**ADDENDUM NO.:** 02  
**PROJECT NAME:** North Park Village (NPV) Administration-Building C (Bid Package 1 – Campus Signage)  
**PROJECT NO.:** 04038  
**DATE OF ISSUE:** 6/13/2023

## **NOTICE OF CHANGES, MODIFICATIONS, OR CLARIFICATIONS TO CONTRACT DOCUMENTS**

## CAMPUS SIGNAGE PACKAGE

### ADDENDUM # 2

2 - EXISTING SIGNAGE REFERENCE IMAGES

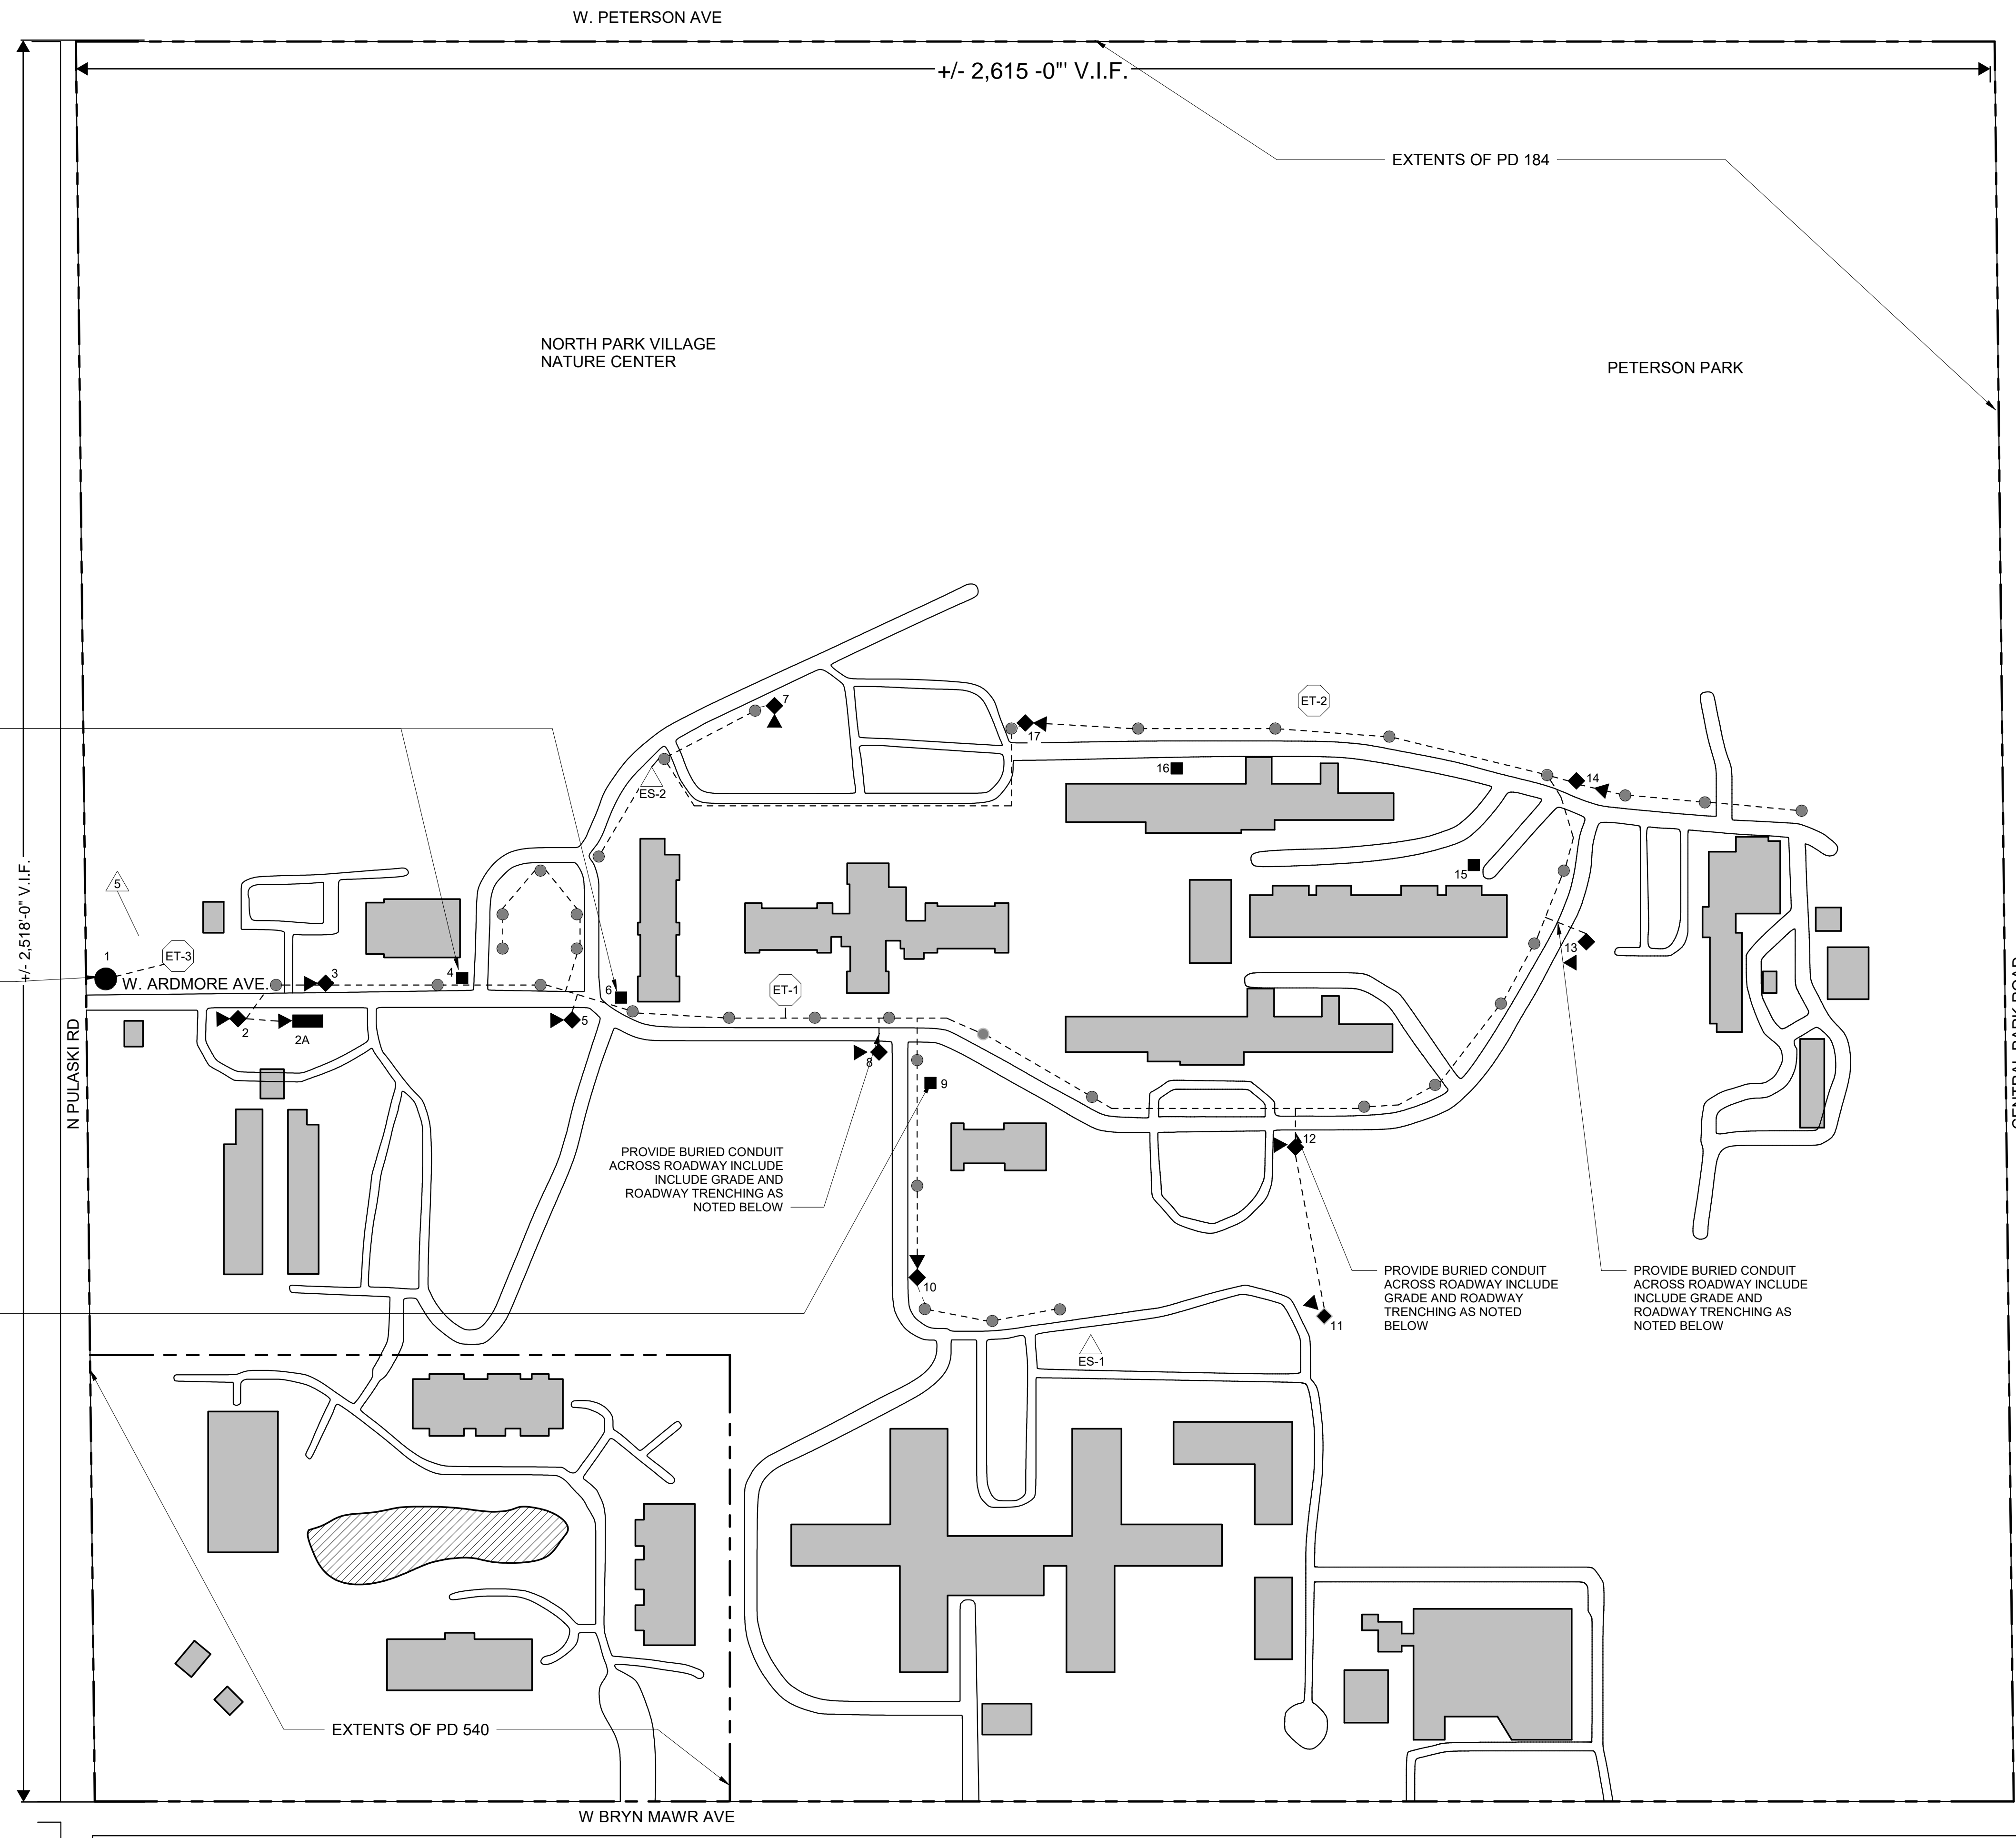
**ITEM NO. 4: REVISIONS TO TECHNICAL SPECIFICATIONS & DRAWINGS**  
**Change 1** Revised Cover Sheet – Updated Title  
**Change 2** Revised A-900 General Notes - added note 13 for mechanically fastened signage letters.  
**Change 3** Added Existing signage reference images added to A-900.

**Question 7** It looks like we are required to remove the existing signs and the sign foundations. Do you have shop drawings for the existing signs that show the current foundations?

**Answer:** The Team does not have shop drawing or legacy drawing information available. Photos of existing signage to be removed have been added to Sheet A-900.
